Report on Assumptions Used in Duke Energy May 2022 Carbon Plan

Bill Powers, P.E., July 15, 2022

Figure 4. Natural gas price projection in the Carbon Plan³⁵

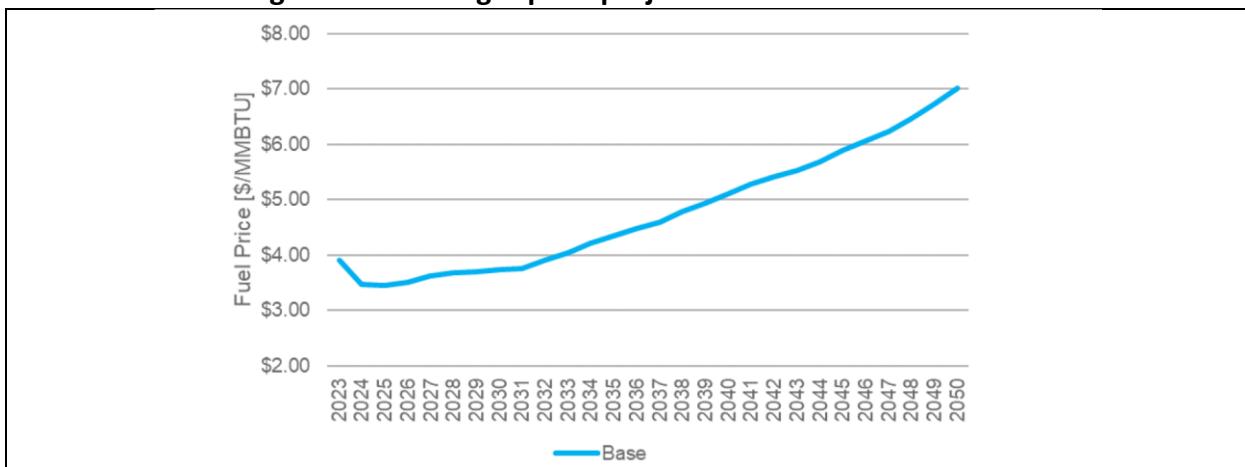
Natural gas price volatility has been an inherent feature of the natural gas market, as shown in Figure 3. Natural gas prices have been especially volatile in 2022, with the May 2022 Henry Hub price over \$8 per million Btu. Western Europe has become a high demand, priority delivery point for U.S. natural gas in the form of LNG in the wake of the Ukraine war, driving increases in U.S. natural gas prices. Yet the Carbon Plan assumes a low base price for natural gas, under \$4/MMBtu through 2032 rising to \$5/MMBtu in 2040, as shown in Figure 4.

The price of natural gas is volatile over time, as shown in Figure 1. In contrast, there is no price volatility over time in the price (free) or availability of solar power.

Figure 5. Relationship of battery capacity to ELCC value for the solar plus battery case⁶⁸

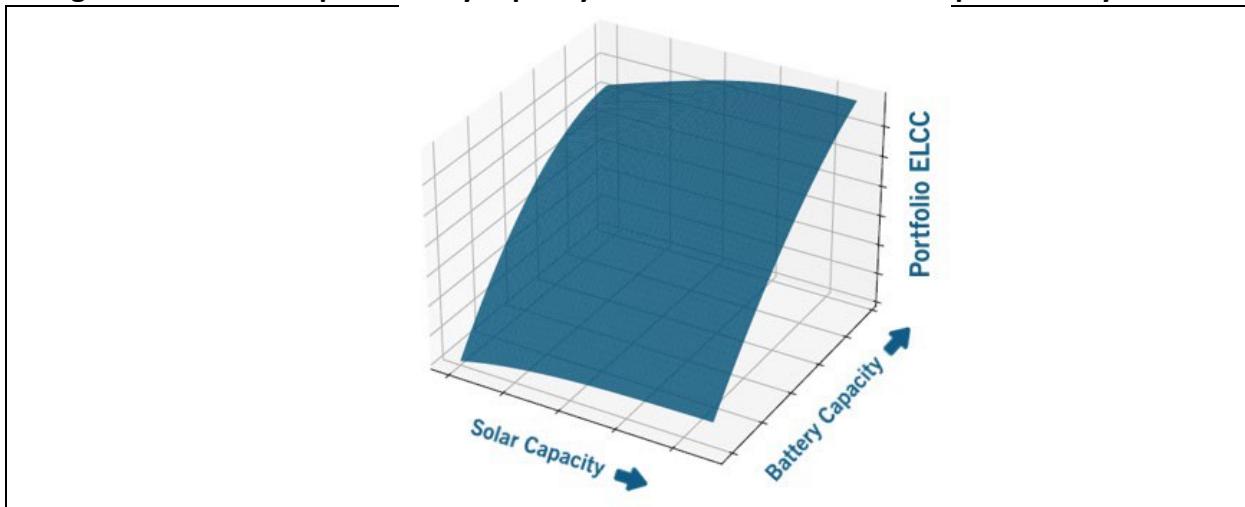
This result is achieved by assuming the solar with battery storage alternative only has about one hour of battery storage in the Electric Load Carrying Capability (ELCC) analysis, and by assuming winter peak conditions when little solar power is available. The ELCC is the "capacity value of a resource and can be thought of as a measure of the reliable capacity contribution of a resource being added to an existing generation portfolio."⁶⁷ The more battery storage that is added to the solar resource, the higher the ELCC value, as shown in Figure 5.

The utility-scale solar plus battery building block in the Carbon Plan ELCC analysis is a 75 MW solar array coupled to 20 MW of battery storage with 80 MWh of storage capacity.⁶⁹ This is approximately one hour of storage at the solar array design capacity of 75 MW.⁷⁰ Not surprisingly, this inadequate amount of storage results in the solar plus storage alternative having a low ELCC.⁷¹

The Companies ELCC modeling indicates that as more-and-more battery storage capacity is added, longer-and-longer battery durations are needed to maintain high ELCC values. That is what should be modeled. What should not be modeled is a single solar plus battery storage profile with a badly undersized battery storage component. The predictable result is that solar plus battery storage will provide little contribution to reliable capacity, and therefore must be supplemented with other resources like CTs.

Recommendation: The Companies should model three new solar plus storage profiles, solar plus 4-hour storage, solar plus 6-hour storage, and solar plus 8-hour storage, and provide the ELCCs for those profiles in a revised Carbon Plan.

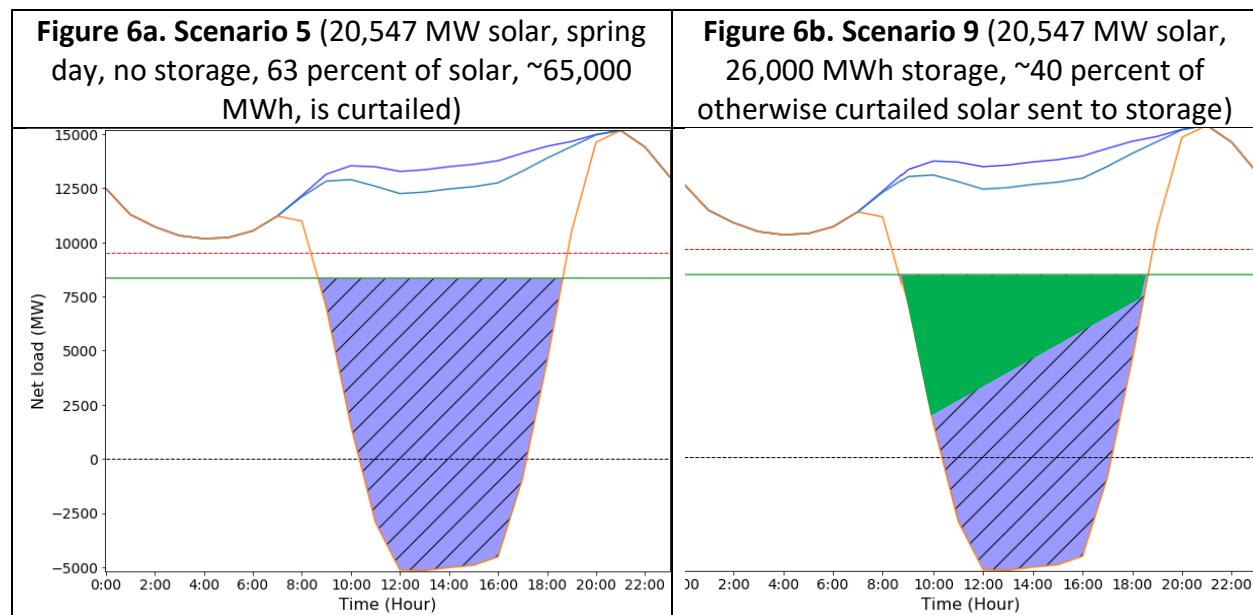
Scenario 9 misstates the ability of storage to fully absorb the excess solar generation by including far too little storage in the scenario. Scenario 9 matches 20,547 MW of solar capacity with 26,000 MWh of storage.⁷⁷ This equates to about one-and-a-quarter (1.25) hours of storage per MW of solar capacity.⁷⁸ This is similar to the ratio in the scenario that the Companies adopt in the Carbon Plan: 75 MW of solar capacity is combined with 80 MWh of battery storage. This equals 1.07 hours of storage per MW of solar capacity⁷⁹

This is shown in Figure 6. The NREL study estimates that on a spring day, with 20,547 MW of installed solar capacity and no additional storage, about 63 percent of that spring day solar

production – about 65,000 MWh⁸¹ – would have to be curtailed, as shown in Figure 6a. If 26,000 MWh of storage is added, consistent with Scenario 9, 40 percent of this 65,000 MWh of solar power would be directed to storage, while the other 60 percent would be curtailed. This is shown in Figure 6b, where 40 percent of the otherwise curtailed solar power is directed to storage (green fill).

Figure 7. Modified Scenario 9 with an increase of storage capacity to 65,000 MWh
 (all solar power that would otherwise be curtailed is directed to storage)

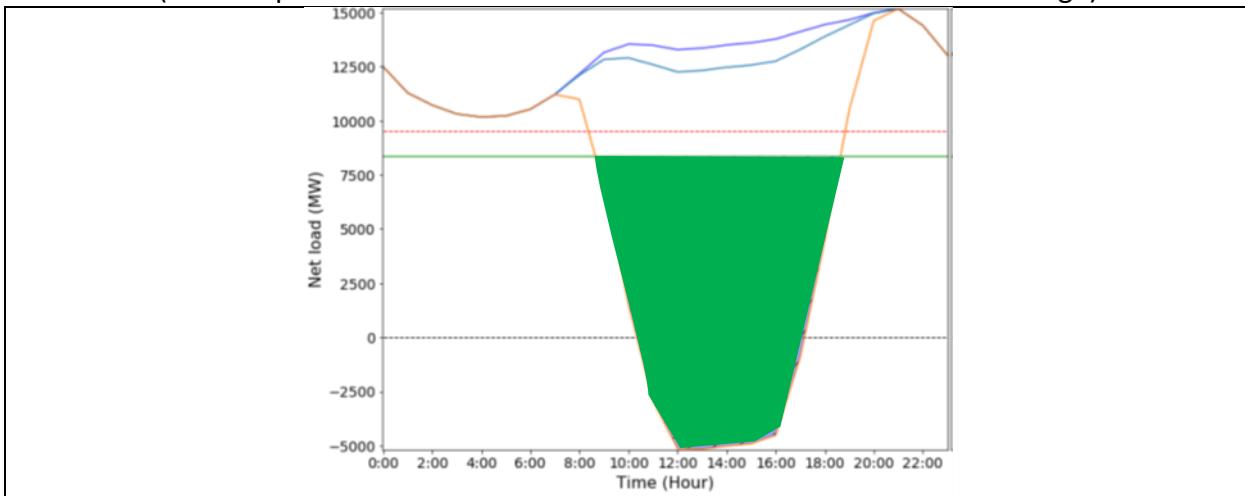
What is missing from the 2020 NREL study, and from the Companies' Carbon Plan, is the scenario (or scenarios) that increases battery storage capacity sufficiently to eliminate, or nearly eliminate, solar power curtailments under light load spring and fall day conditions and to maintain the solar plus storage ELCC at or near 100 percent. For example, if Scenario 9 were modified to increase the amount of storage to 65,000 MWh, then the amount of solar curtailment in Scenario 9 would be reduced to zero as shown in Figure 7.

Figure 8. Comparison of Duke Energy actual demand growth to forecast demand growth¹⁴⁵

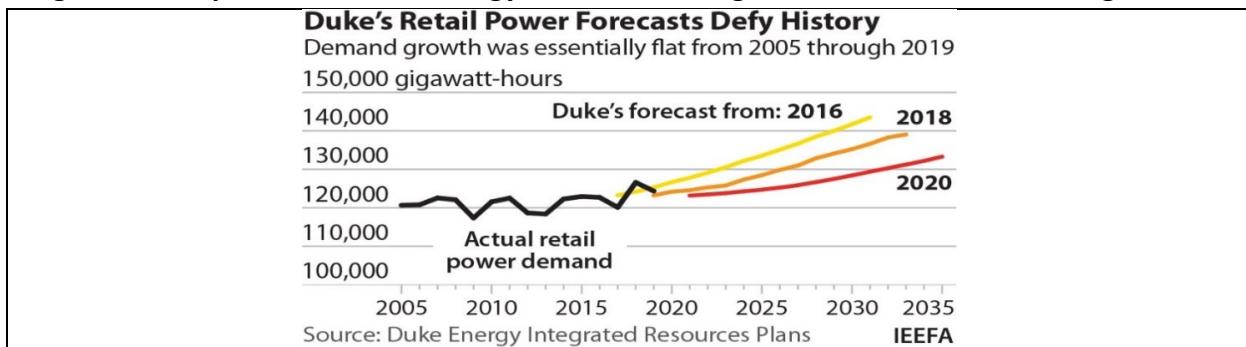
DEC and DEP have consistently overestimated demand growth in their respective service territories, as shown in Figure 8.

Actual DEC retail sales growth from 2016 through 2021, the most recent five-year period shown in the Carbon Plan, averaged 0.0 percent.¹⁴⁶ The Companies analyze the period 2012 to 2021 to assert a sales growth rate forecast for DEC of 0.8 percent.¹⁴⁷ 2012 was a relatively low retail sales year, as can be seen in Figure 8. Using 2012 as the base year gives the impression of significant demand growth over time, when review of the record going back to 2007 shows no growth. The Duke Energy retail sales growth rate forecast used in the Carbon Plan is not supported by actual historical DEC retail demand.

The last fifteen years of data on the Companies’ annual retail sales (Figure 8) and winter peak demand trends¹⁵⁶ provide no basis for projecting any annual energy demand or peak load growth going forward. Much of the CT and nuclear build-out proposed by the Companies in the 2035 to 2050 timeframe is designed to meet load growth that is highly unlikely to materialize.
